Appendices A, B, C, and D

Final Environmental Assessment

Yuma Desalting Plant Pilot Run

Figure 1. Daily Gila River flows, with projected constant and variable MODE discharge. Source: USGS Gage 09520500 Gila River near Dome.

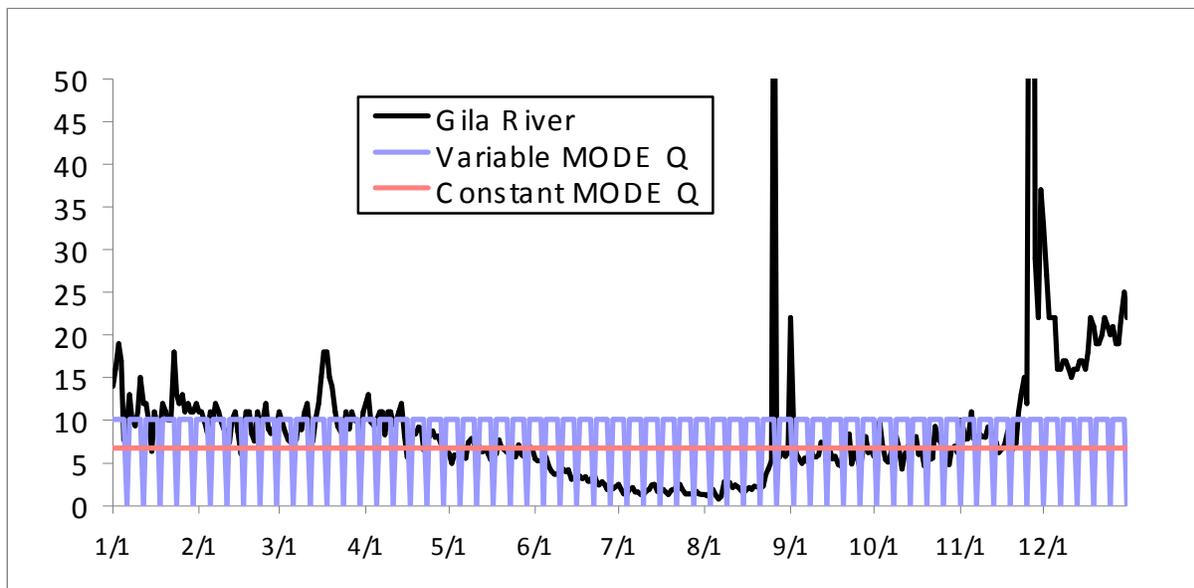
River near Dome dropped as low as 0.78 cfs. Reclamation fails to disclose the proposed mean daily discharge from the MODE 1 Diversion/Return Facility. Assuming a constant rate for the 7,300 AF over the 18-month period of the proposed action yields a daily rate of 6.7 cfs. Application of Reclamation’s operating assumption that the YDP would operate 83% of the time over the 18 months, Draft EA at App. C, p. 2, with further assumption that the discharge of MODE water through the MODE 1 Diversion/Return Facility is timed to match this operating schedule, yields a five-day discharge of 10.1 cfs, followed by a one-day zero discharge. Figure 1, below, plots daily flow of the Gila River near Dome in 2008, as reported by USGS gage 09520500, against the constant and variable projected daily discharges of MODE water, at 6.7 cfs and 10.1 cfs, respectively. This figure is intended to show the potential magnitude of the MODE discharge relative to the daily flow of the receiving body, but is purely speculative given that daily MODE diversion data was not included in the draft.

Presumably, the daily salt loadings to the Gila River would have significant impacts on water quality, especially in the normally low-flow summer months. While the addition of 7,300 acre-feet of water over twelve to eighteen months will not significantly affect the level of the Colorado River at or below its confluence with the Gila, it will have a calculable and significant impact on the level of the Gila River over the ten miles before it joins the Colorado. Reclamation must describe and evaluate these impacts.

6-32	<p>The actual discharge point into the Gila River is approximately 400 yards upstream of the confluence of the Gila and Colorado Rivers. Please see Figure 2-1 in the EA.</p>
6-33	<p>A permit for the discharge of MODE drainage water is not required and has not been requested.</p>
6-34	<p>Reclamation submitted an application for an APP. Reclamation did so voluntarily, as neither the CWA nor any other federal law requires this permit.</p>
6-35	<p>Section 3.6, Hazardous Materials, has been expanded to better describe possible impacts and mitigation measures.</p>
6-36	<p>As noted in comment response 6-28, Section 3.3, Air Quality analysis has been expanded, and substantiates the previous conclusions made in Section 3.8, Environmental Justice, that there would be no disproportionately high and adverse human health or environmental effects impacts on minority or low-income populations in the U.S.</p>
